REMARKS

Summary of the Office Action

Summary of the Response to the Office Action

2/10

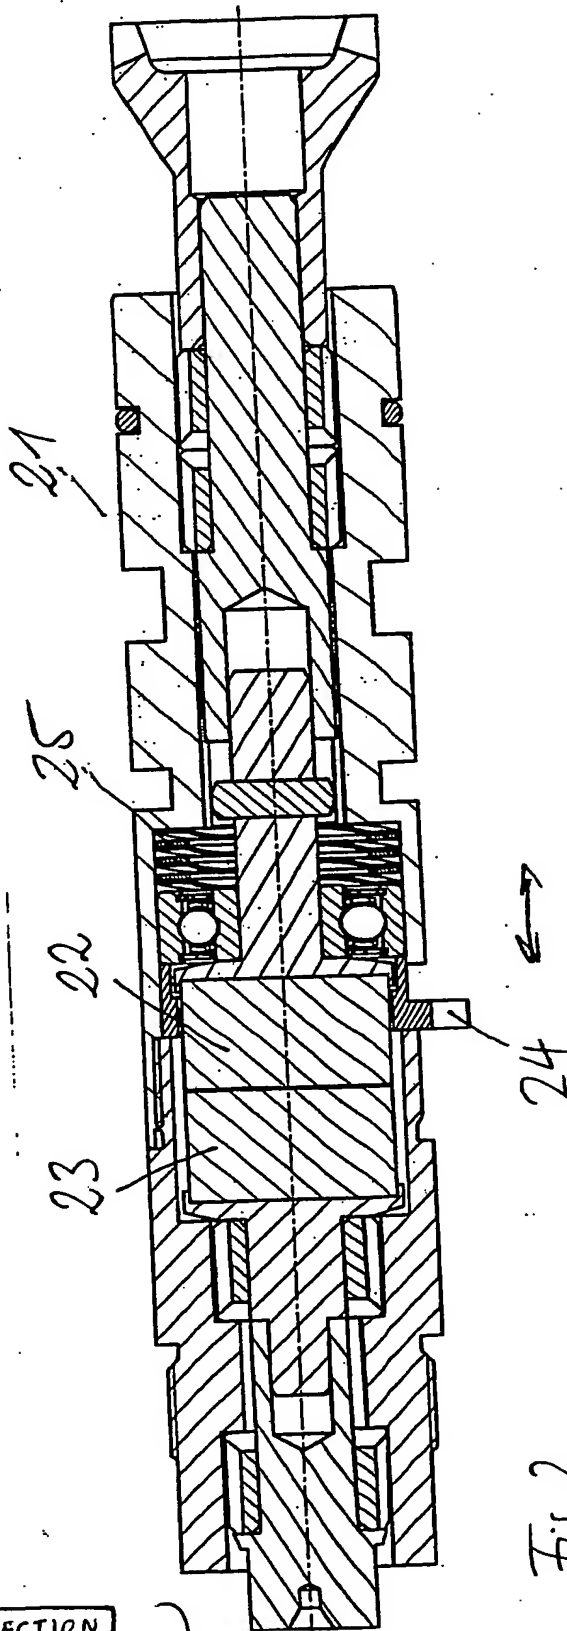
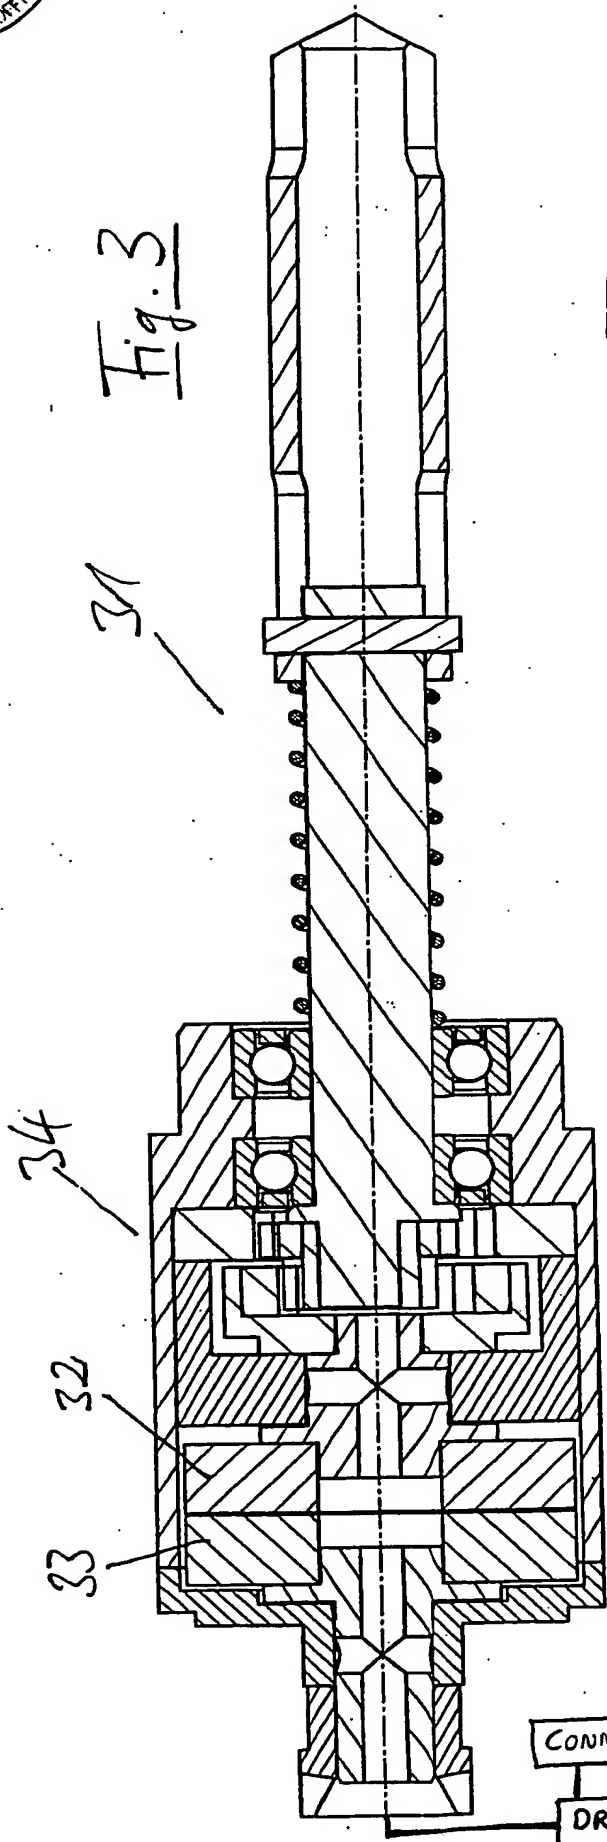
With regard to dependent claim 12, the Office Action states that the limitations of “a neck drive,” “a drive motor with high rotation speed,” and “a reduction gear,” must be shown. With regard to the aforementioned objection, Applicant respectfully asserts that the limitation of the neck drive 1 is shown in original Fig. 1a, the limitation of the drive motor is now shown in amended Fig. 3, and the limitation of reduction gear 34 is shown in original Fig. 3.

With regard to dependent claim 18, the Office Action states that the limitation of “a connection point is provided on a motor,” must be shown. With regard to the aforementioned objection, Applicant respectfully asserts that the aforementioned limitation is now shown in amended Fig. 3.

CONNECTION POINT

DRIVE MOTOR

FIG. Label Added.
